NV20, 4MX16 DDR, RGB, EXTERNAL DVI-I, TV-DOWN, TV IF , AGP4X

HISTORY REVISION:

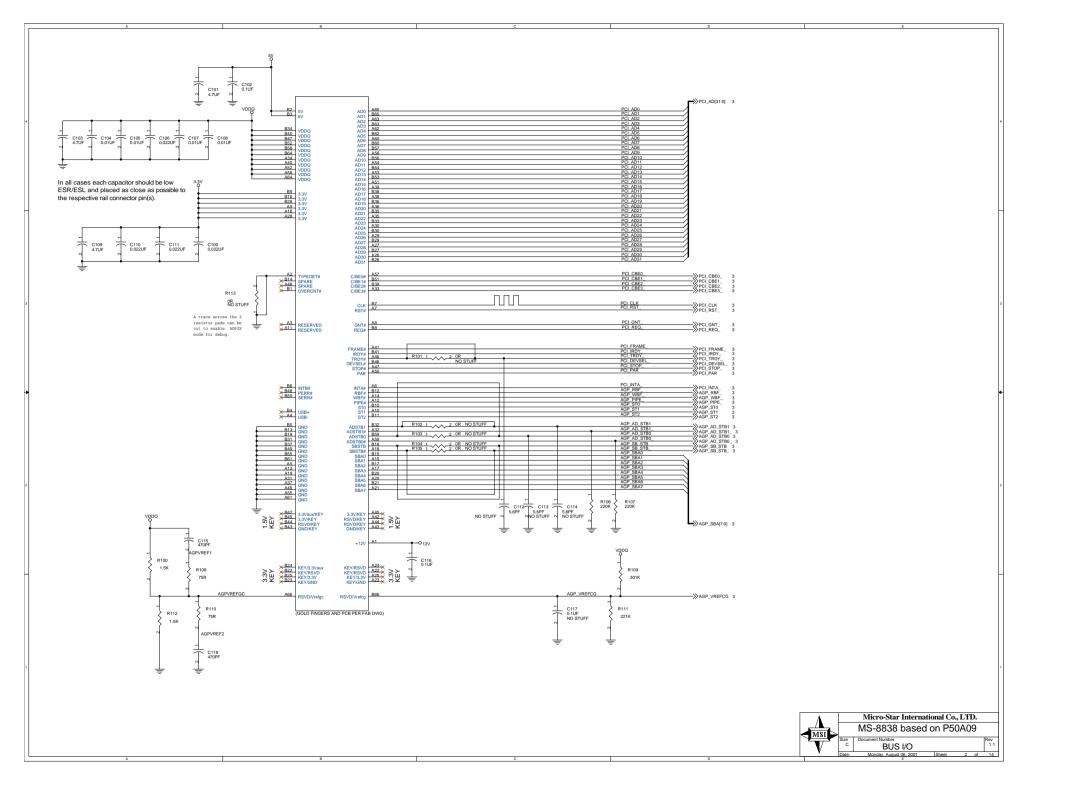
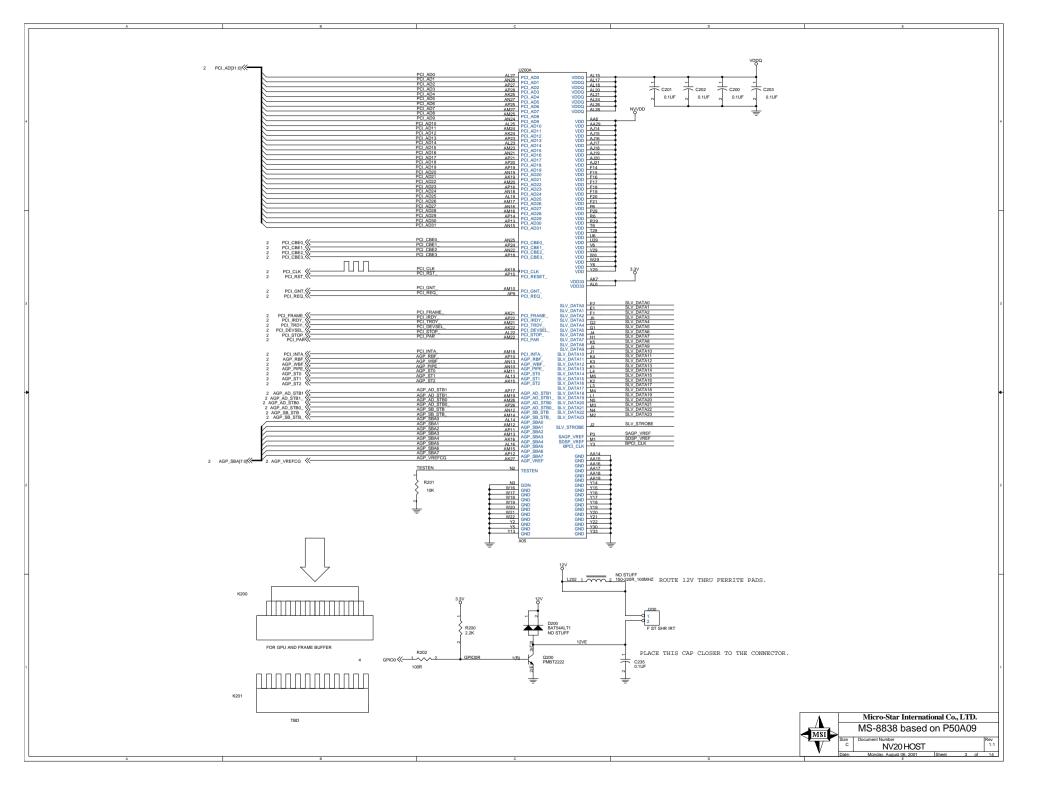
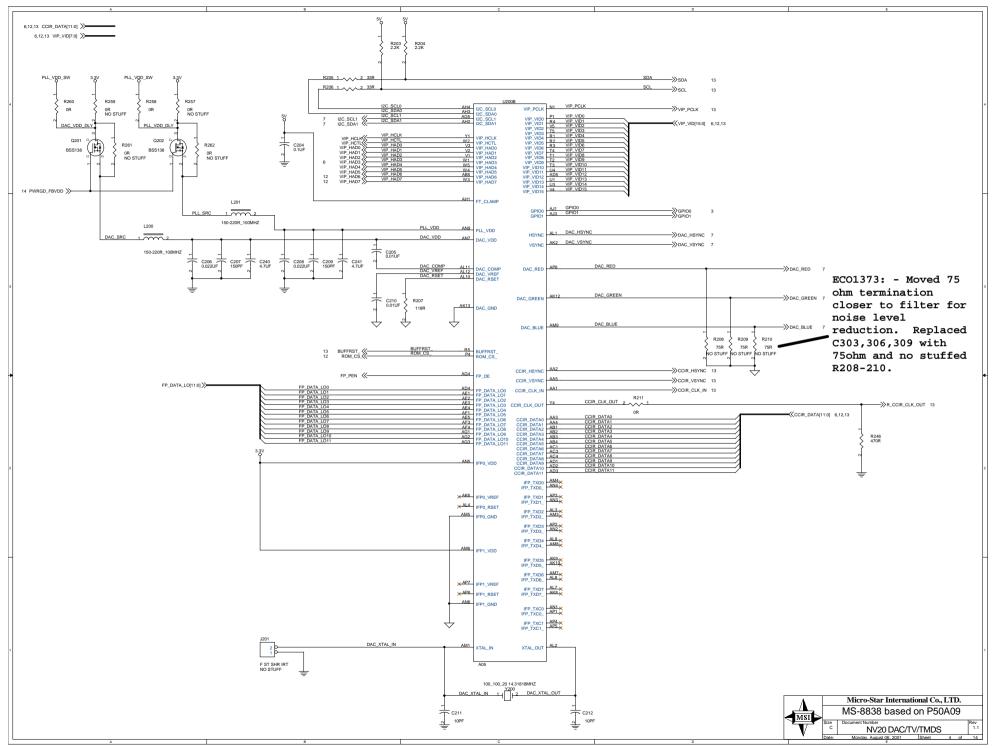
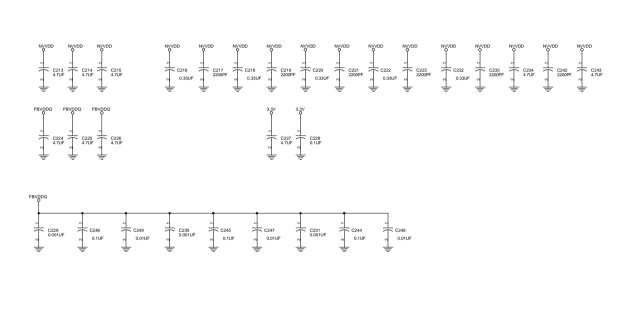
- Changed all memory clk/clk# diff pair resistors to 68R 5% (from 47R)

X04: - Delay PLL_VDD to come up after NVVDD.

X05: - Added 1UF accross R257.

X06: - Removed X04-5 above, added a switcher generated PLL delay option.

- SSENA cap for 2nd SW changed to 1UF.
- A05 Si, NVVDD=1.52V

X02: - Changed PLL VDD and DAC VDD to be gated by Fet controlled by FBVDD

X03: - Added option to pull up power good to 12V

EC01235: - Changed R841 PU to 10K (from 4.7K)

EC01373: - Moved 75 ohm termination closer to filter for noise level reduction. Replaced C303,306,309 with 75ohm and no stuffed R208-210.
